MASTER DEVELOPMENT DRAINAGE PLAN FOR DAVIS RANCH SKETCH PLAN, EL PASO COUNTY, COLORADO

June 2023

SKP232

APPENDIX F DRAINAGE MAPS

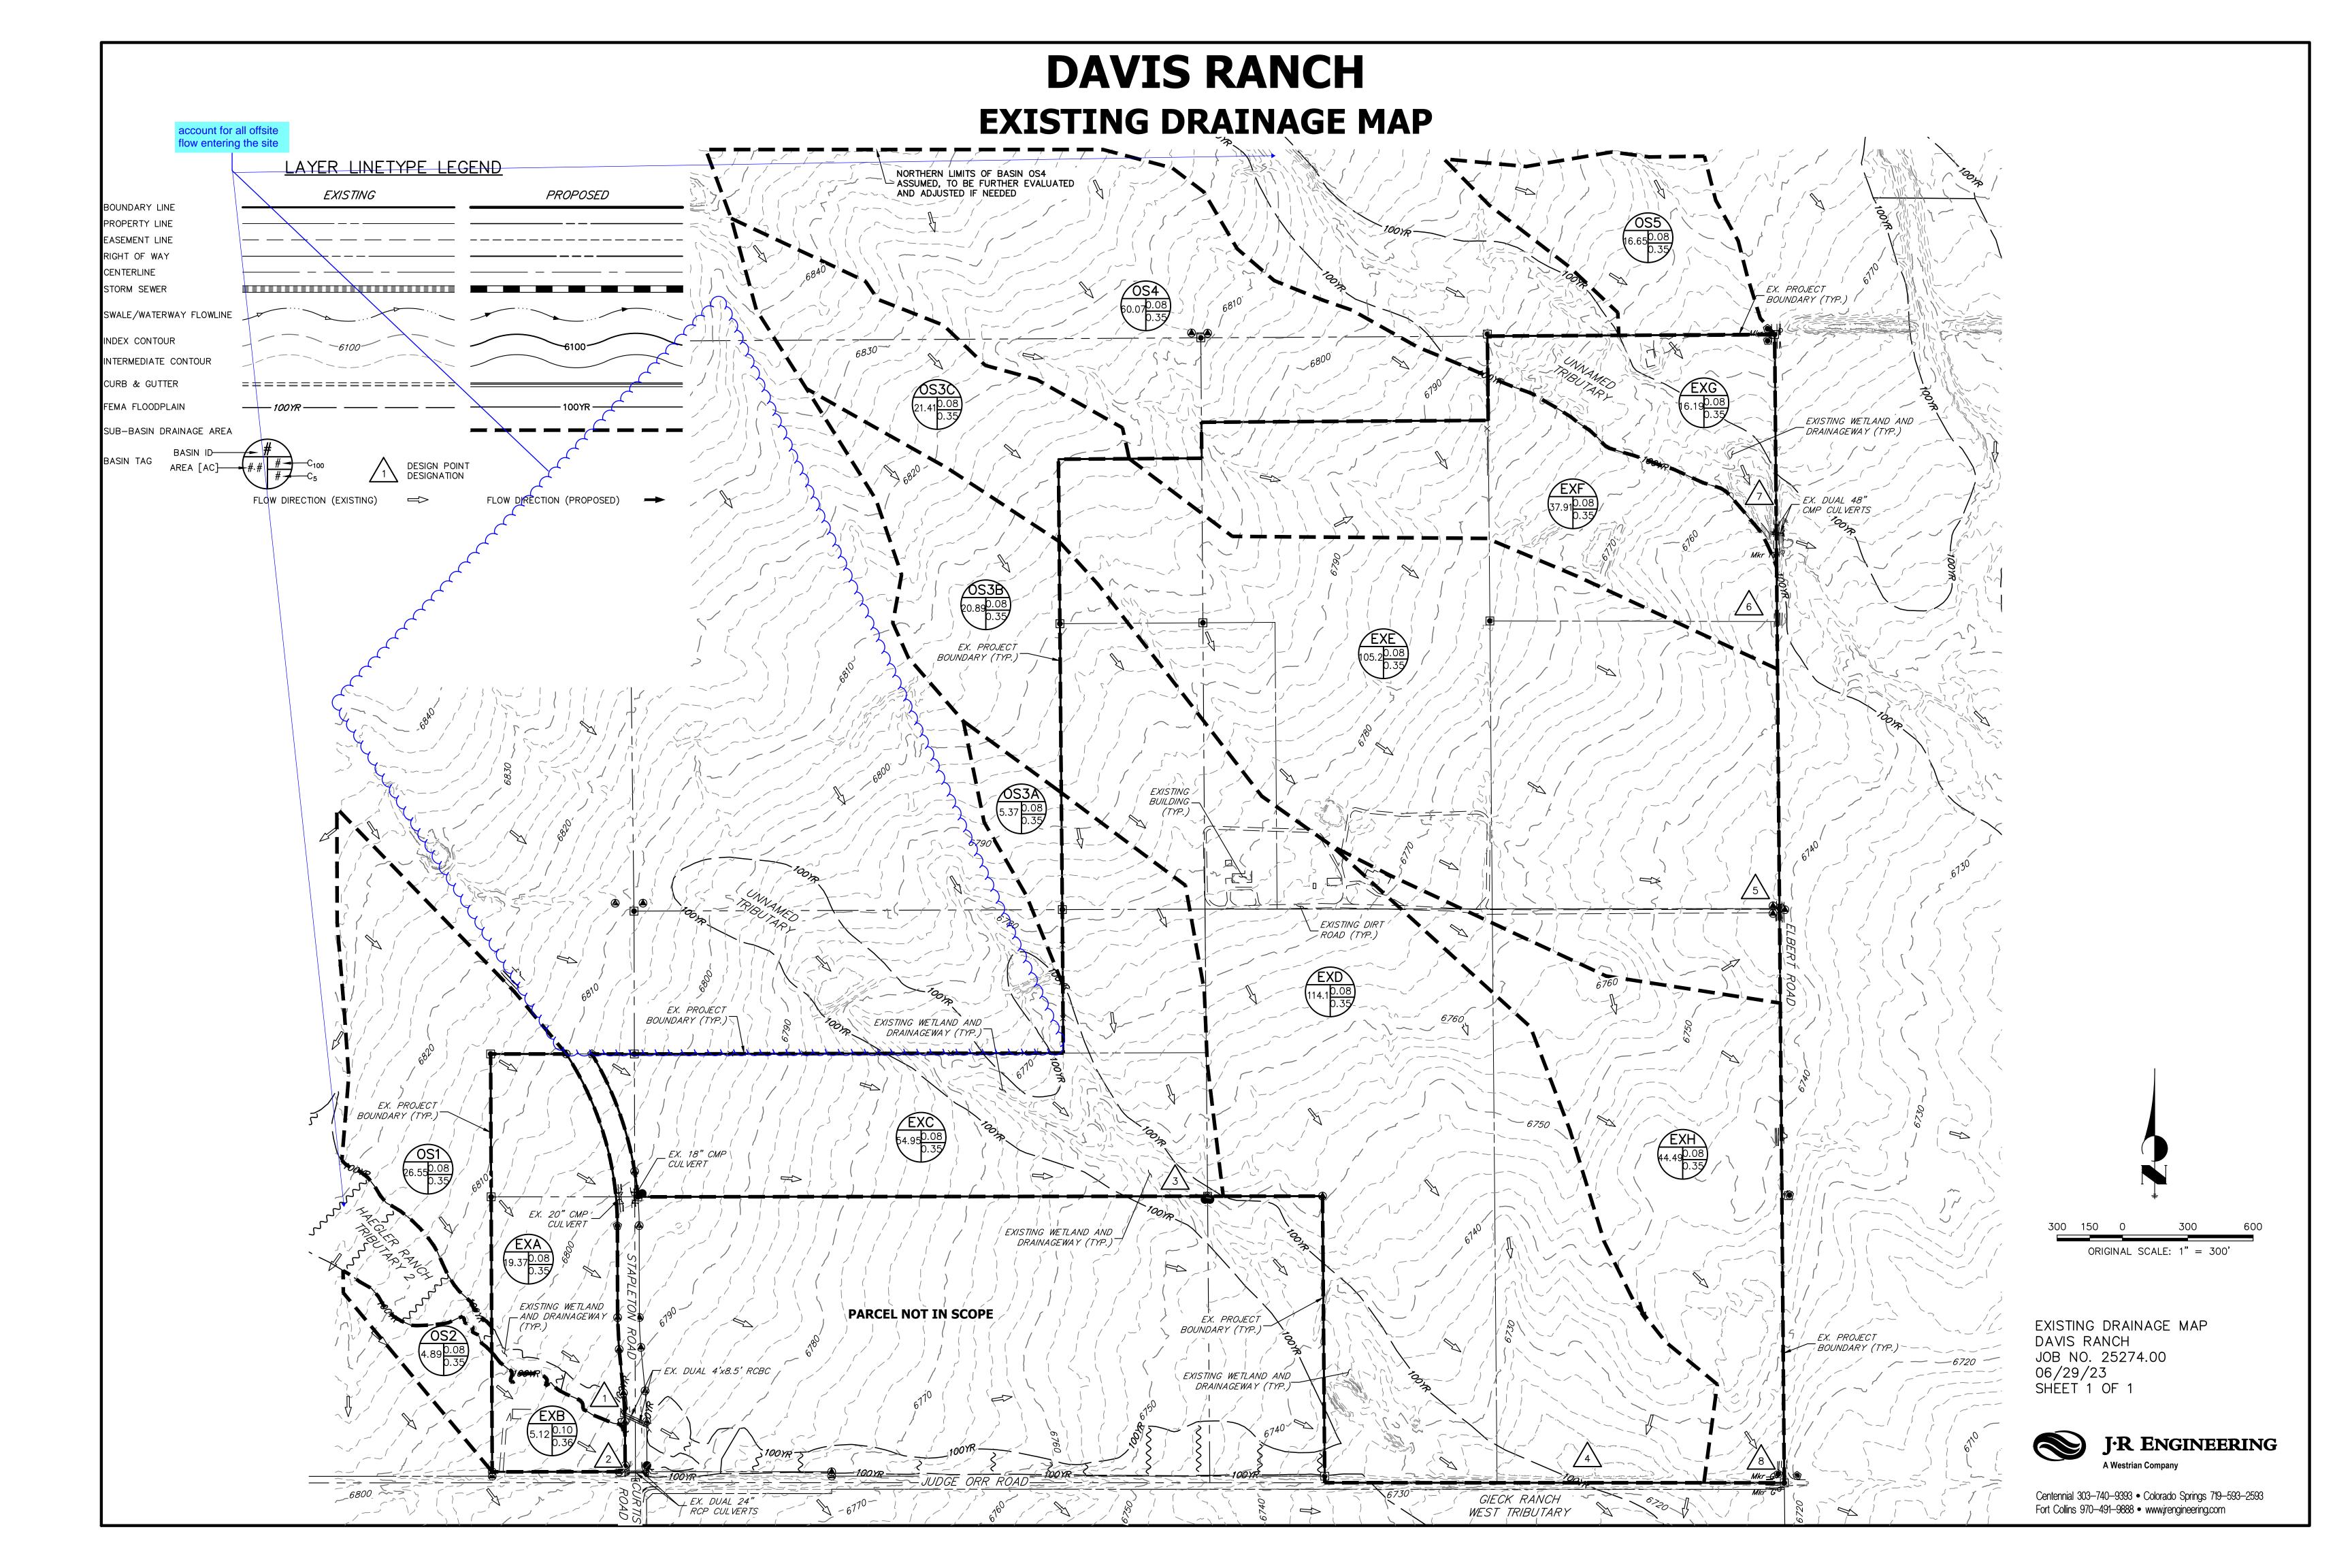
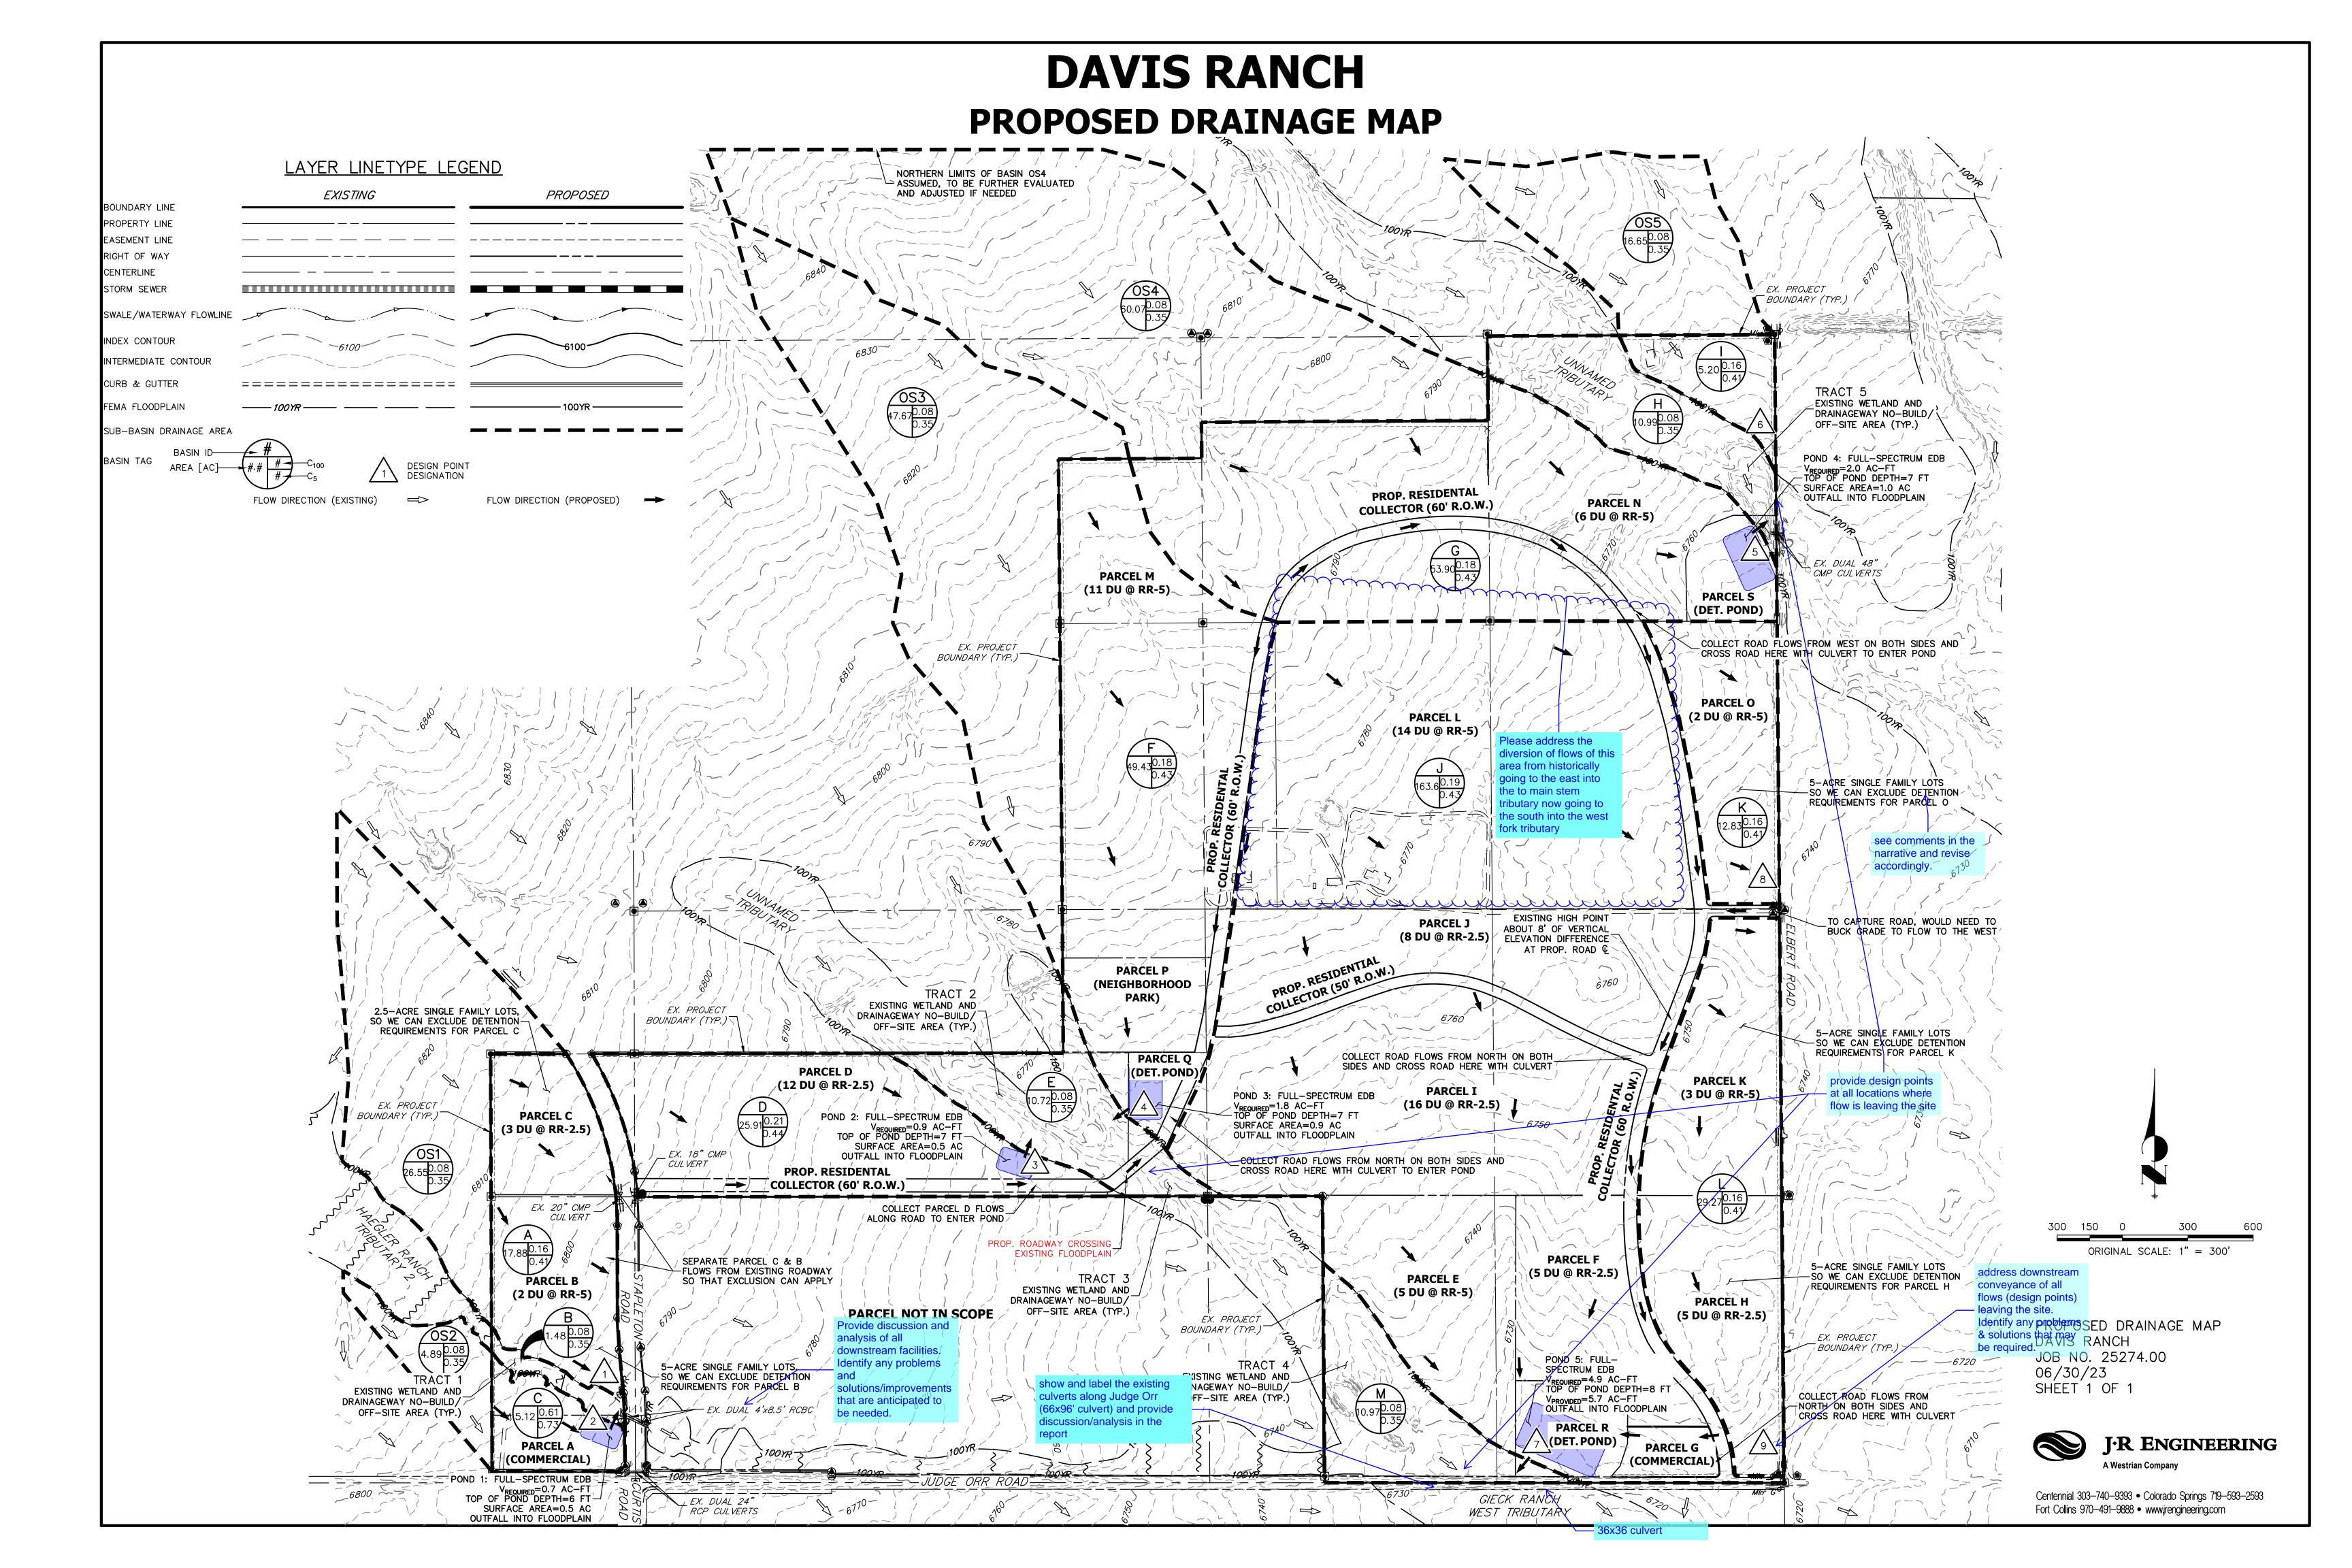
The drainage way does not extend to DP9. Indicate how the flows are conveyed downstream.

Show discharge points as well and clearly show all basins that contribute to the DPs.
